RE: Calico Solar (formerly Solar One) Project (08-AFC-13)
Applicant's Submittal of Alternative Site Layout #2, Engineering Figure with SunCatcher Layout,
and Revised Project Boundary with 4000' Desert Tortoise Corridor Figure

ALTERNATIVE #2 PROJECT LAYOUT

**ALTERNATIVE #2 PROJECT LAYOUT
WITH 4,000 FOOT DESERT TORTOISE CORRIDOR
CALICO SOLAR**

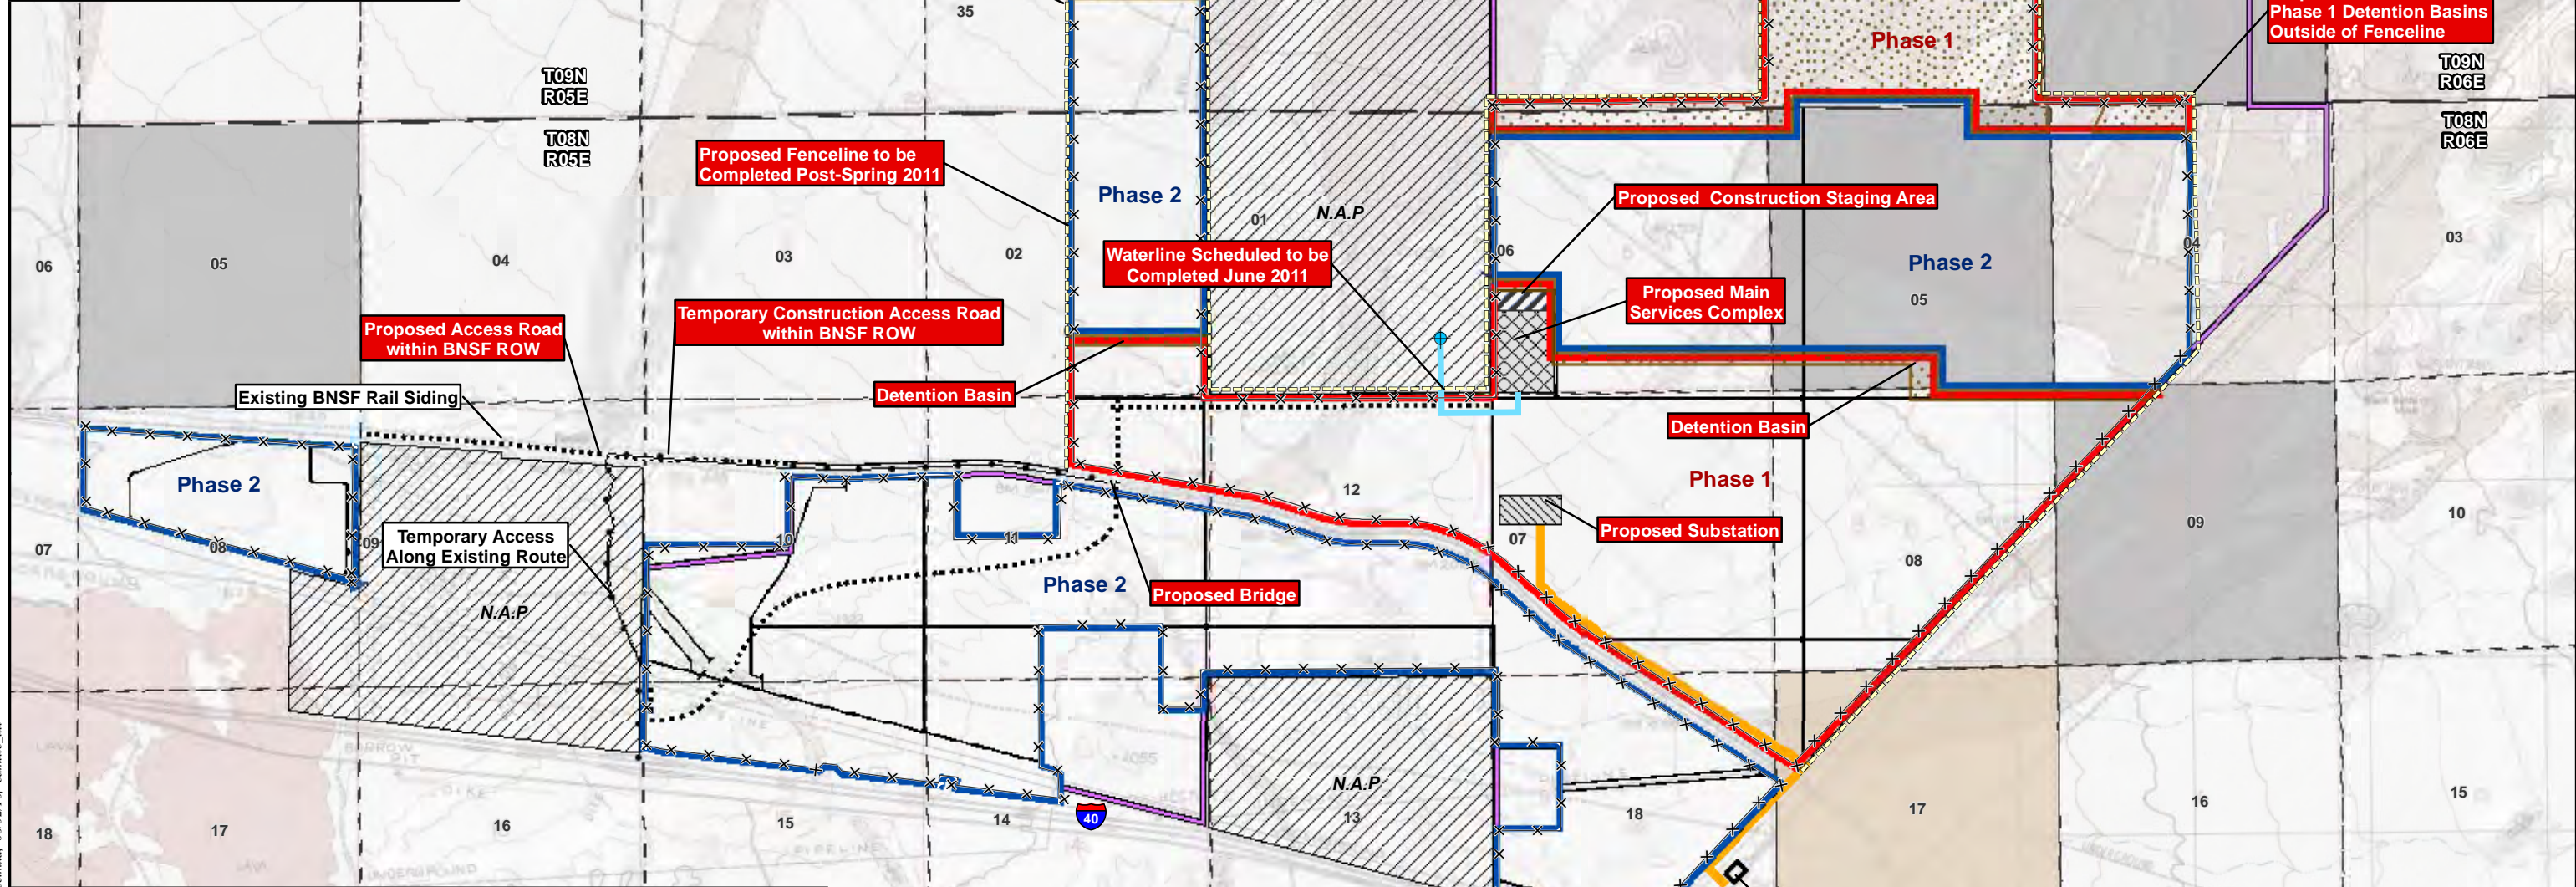
On May 14, 2010 a Supplement was filed that described modifications to the Project's northern boundary. Based on input from the U.S. Fish and Wildlife Service's Desert Tortoise Recovery Office (DTRO) and the Bureau of Land Management (BLM), the northern boundary of the Project site has been further modified to include a 4,000-foot wildlife corridor between the Project (inclusive of all detention basins) and the base of the Cady Mountains. To accommodate this modification, the detention basins were re-configured to extend east to west along the northern Project boundary and the boundary between Phases 1 and 2. Through this change in detention basin design, two objectives are achieved: the detention basins are included within the Project fenceline and outside of the 4,000-foot wildlife corridor, as requested by the wildlife agencies, and the detention basin design maintains the natural drainage patterns of the site.

**Figure 19 -
 Site Plan**

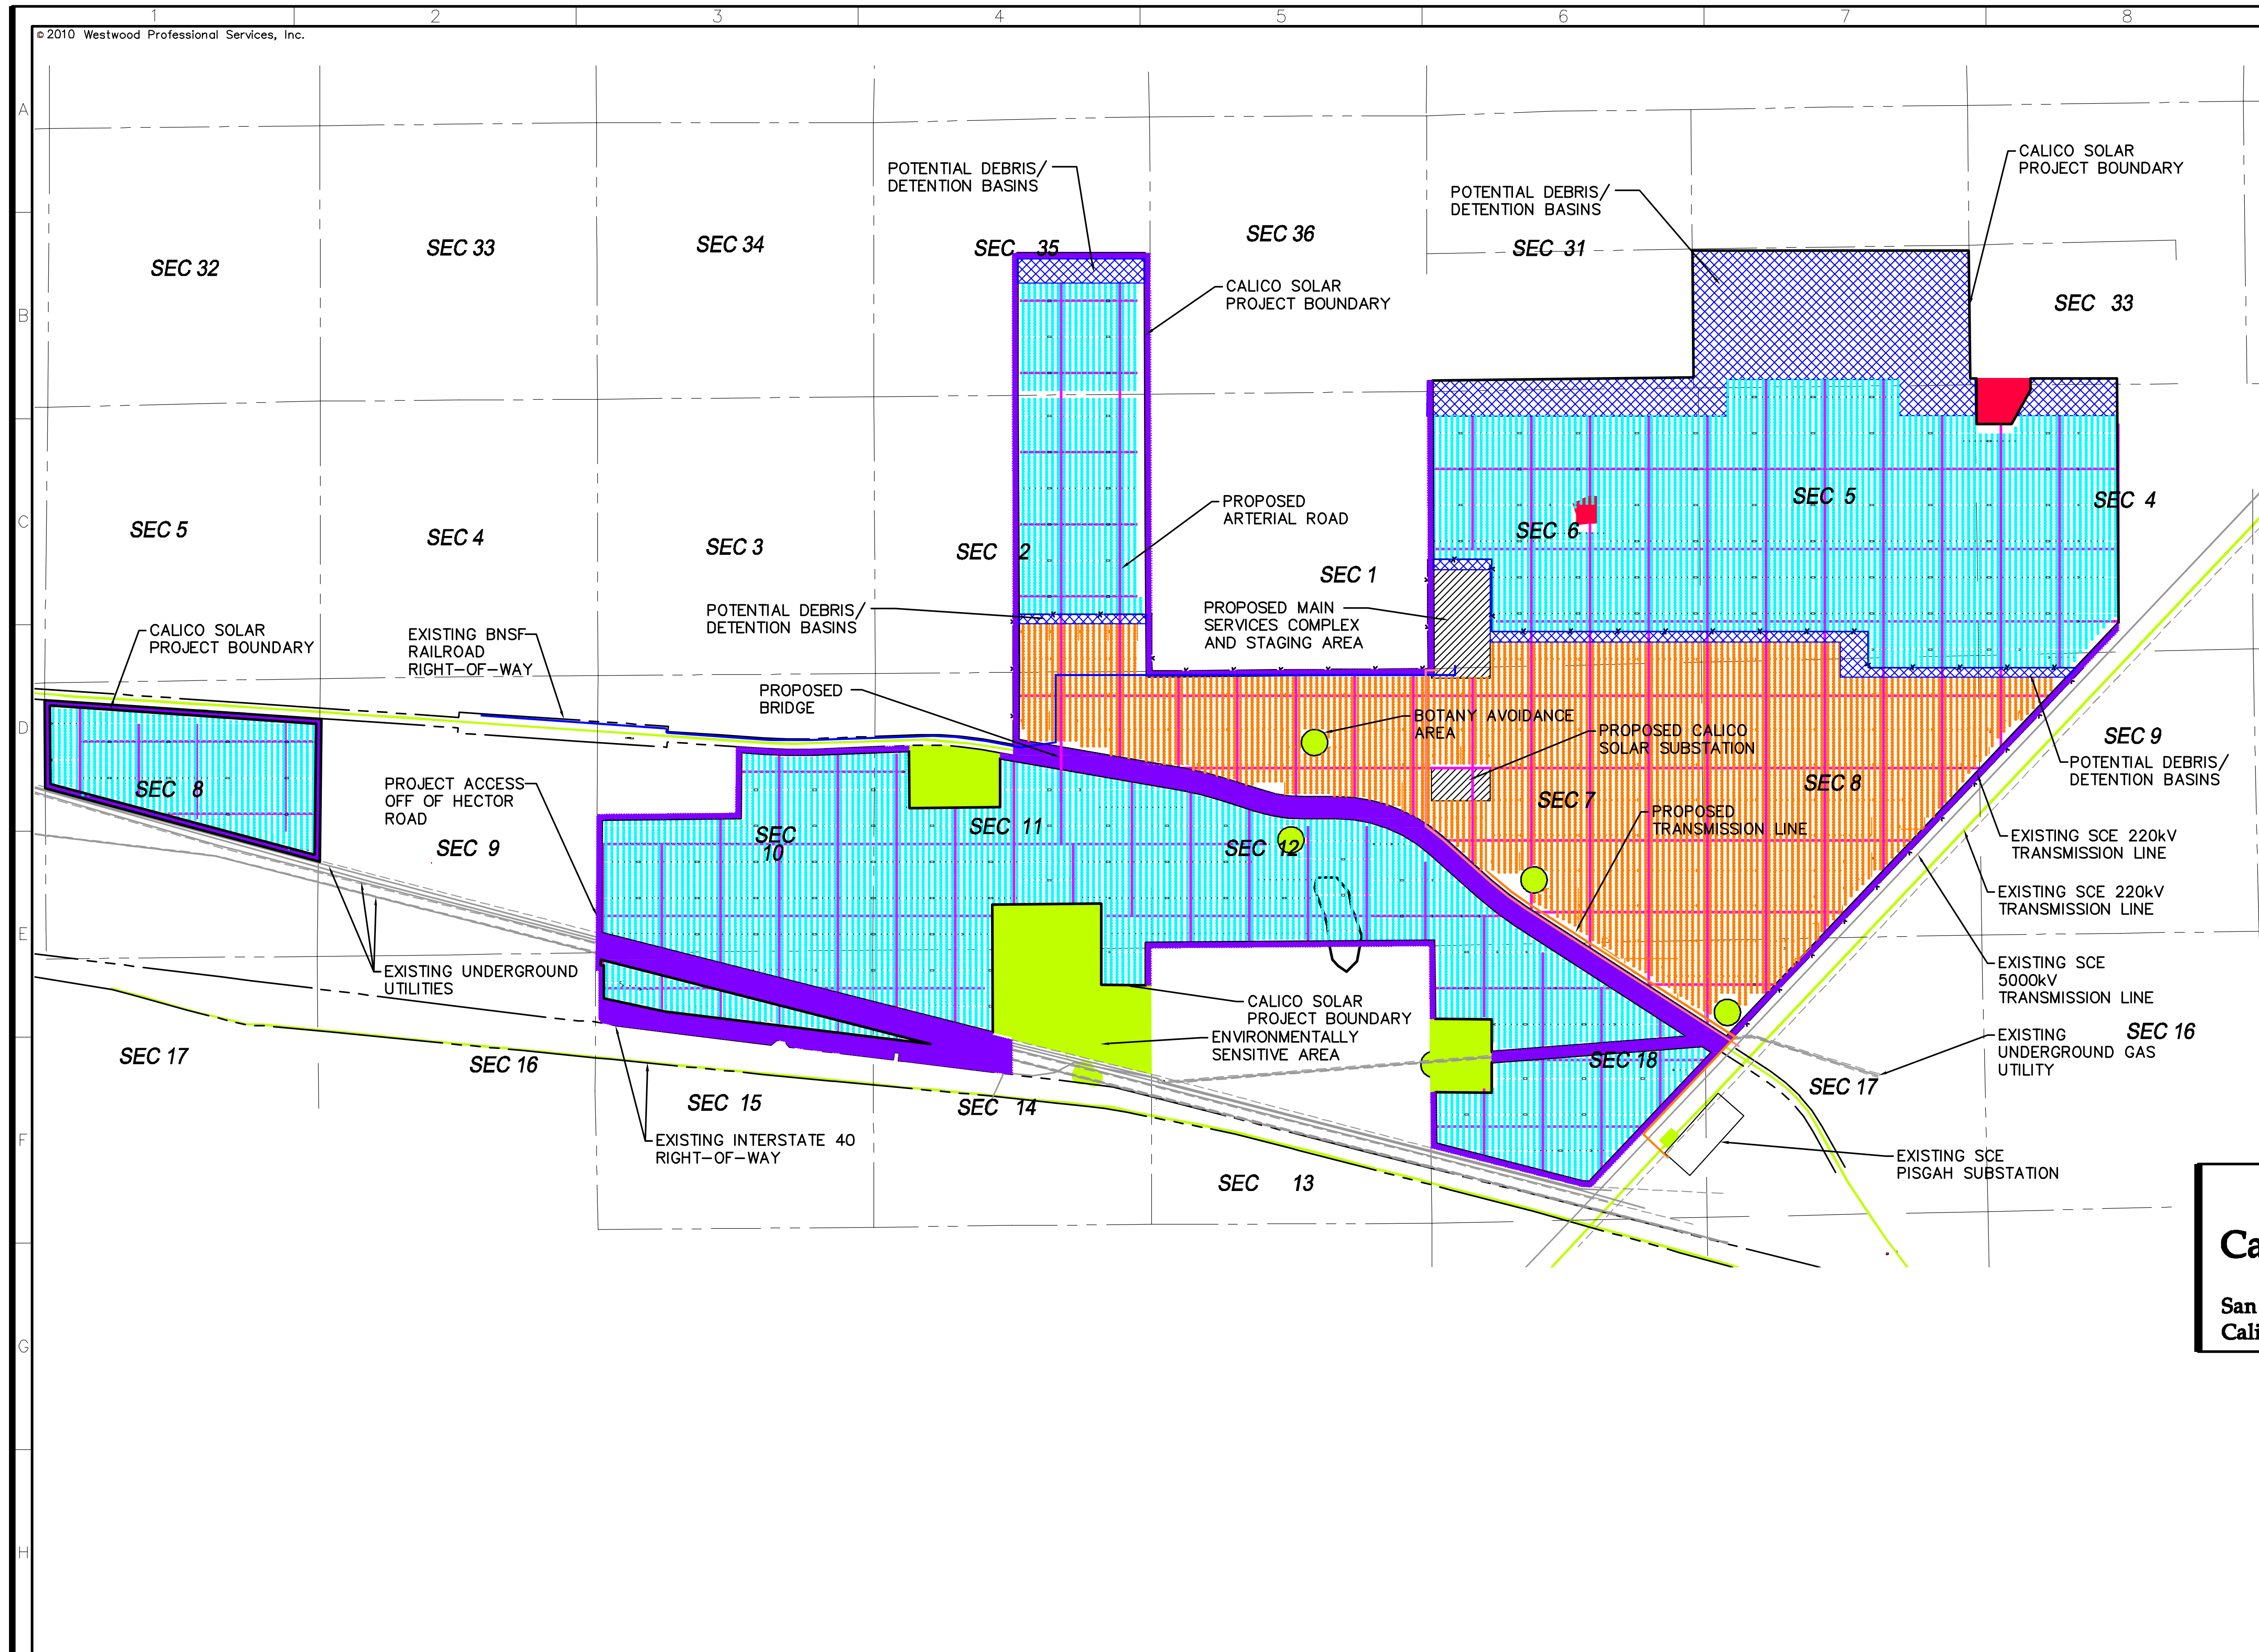
The modified northern Project boundary avoids many of the detected sensitive plant species, as discussed in the Applicant's Submittal of First Round Spring Botany Survey Results. Additionally, the attached current engineering of the SunCatcher layout avoids Environmentally Sensitive Areas (ESAs) south of the railroad and within the Project boundary. The ESAs avoided within the Project boundary include all detected occurrences of white-margined beardtongue.

The Engineering Figure with the SunCatcher layout shows that the Applicant is able to focus development of SunCatchers and support facilities on a smaller footprint and achieve the same level of generation. This will allow the Applicant to meet the requirements of the PPA, avoid environmentally sensitive areas, reduce the loss of desert tortoise, avoid or reduce special status plants as well as pull down from the toe of the Cady Mountains as indicated. It will make construction somewhat more costly, though, given that space for lay-down and movement is more restricted. It should be noted, however, that the spacing between the SunCatchers is not being changed whatsoever.

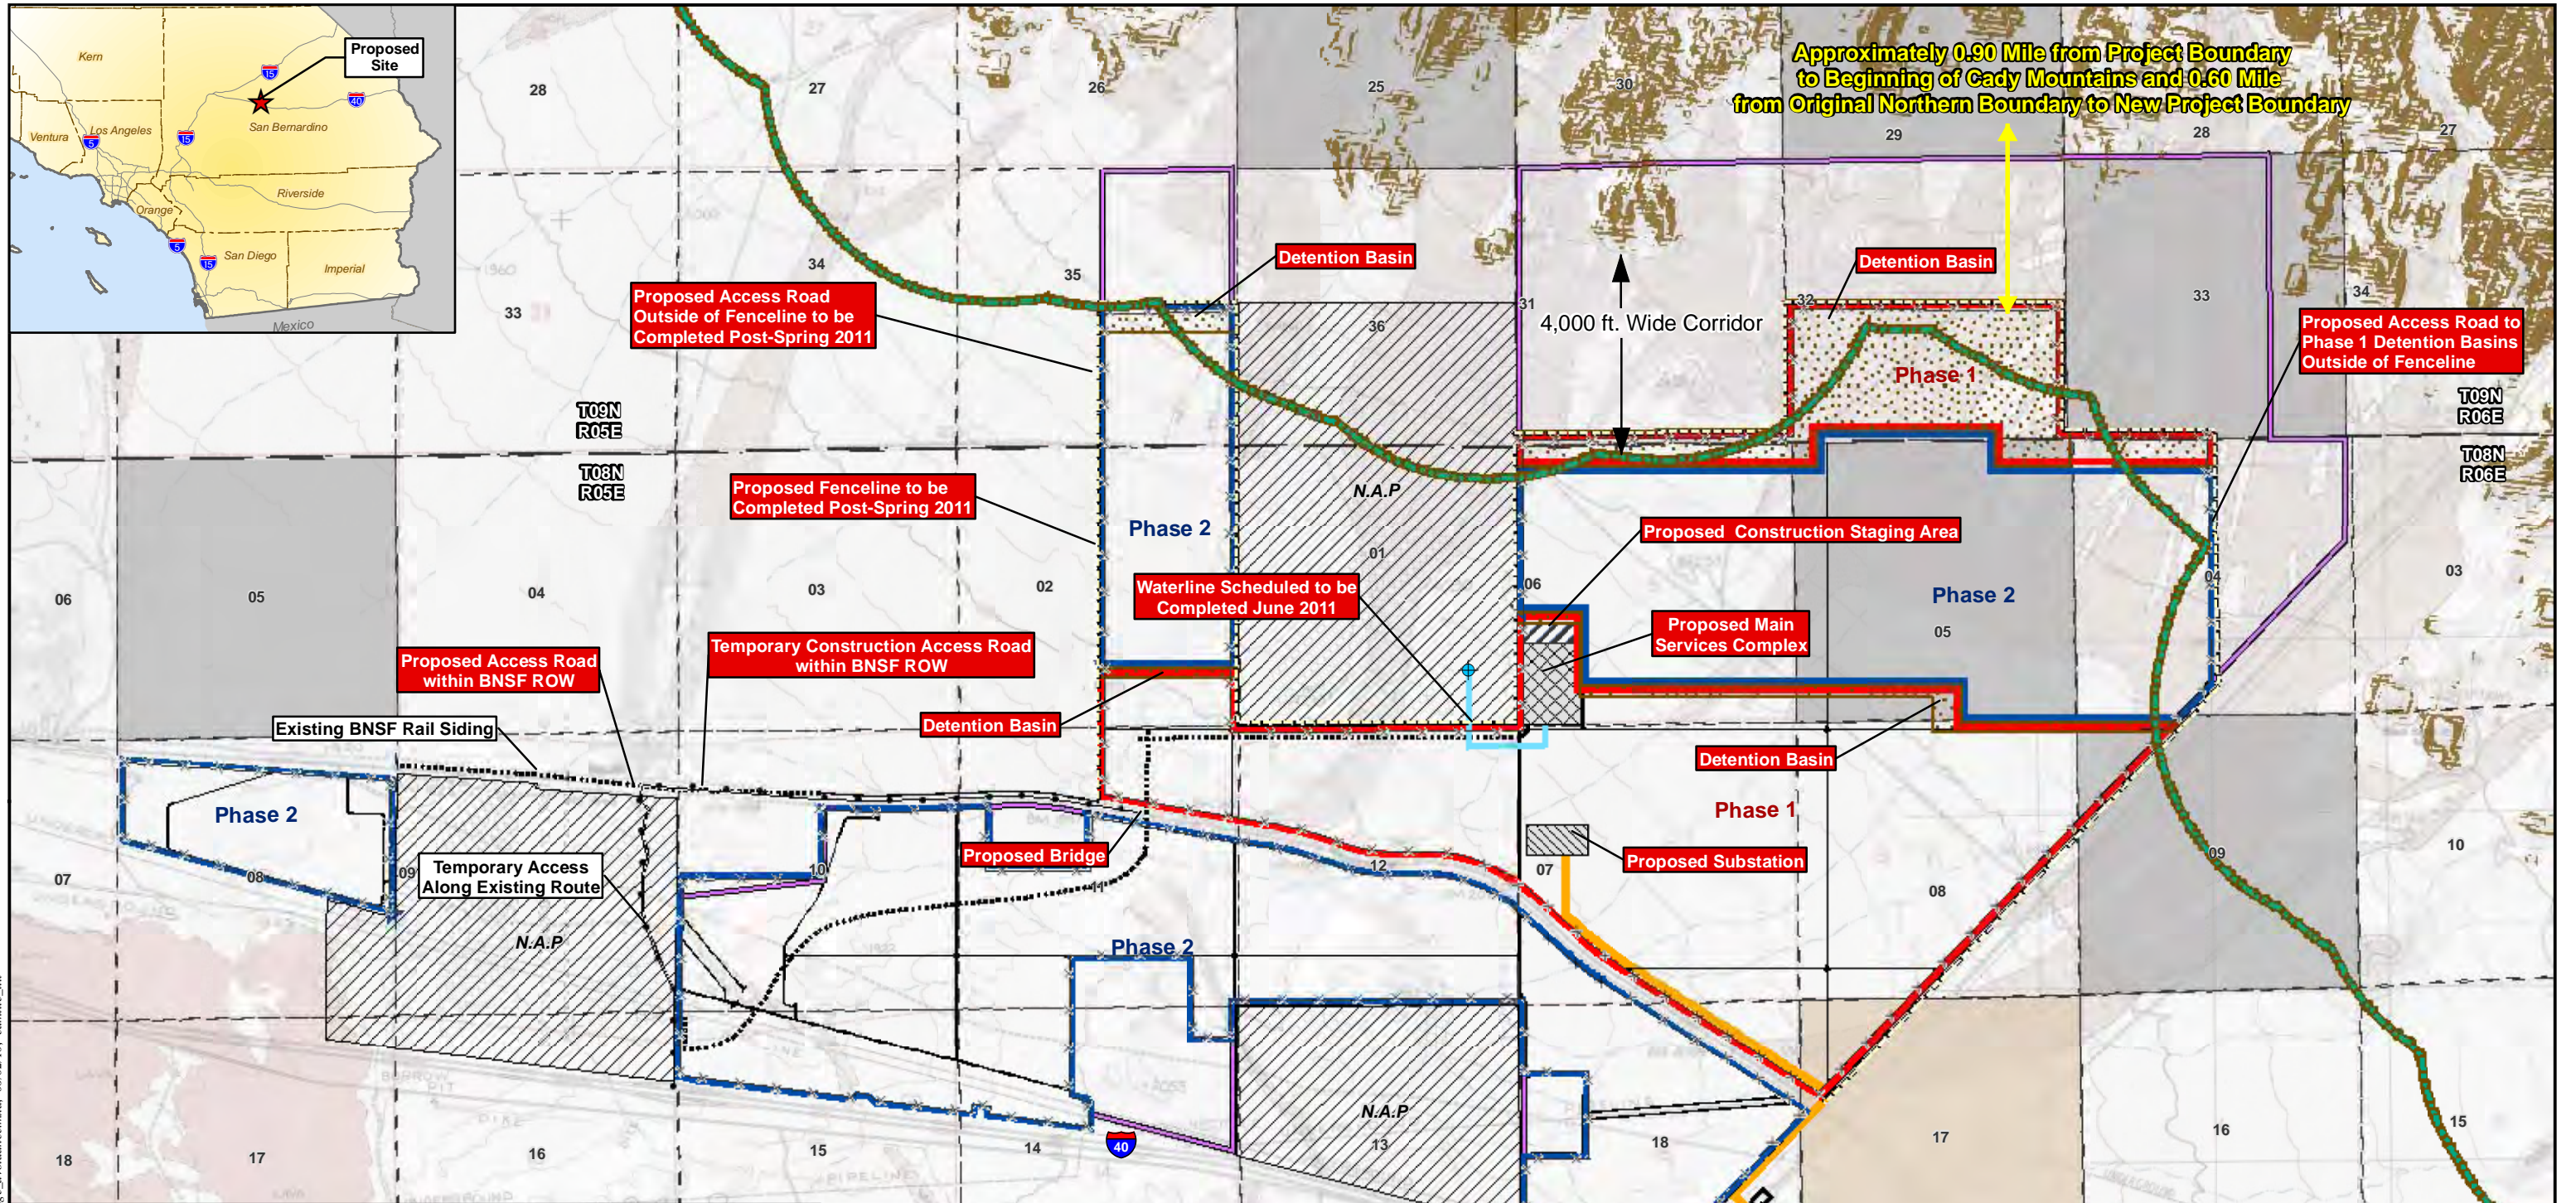
Approximately 0.90 Mile from Project Boundary to Beginning of Gady Mountains and 0.60 Mile from Original Northern Boundary to New Project Boundary
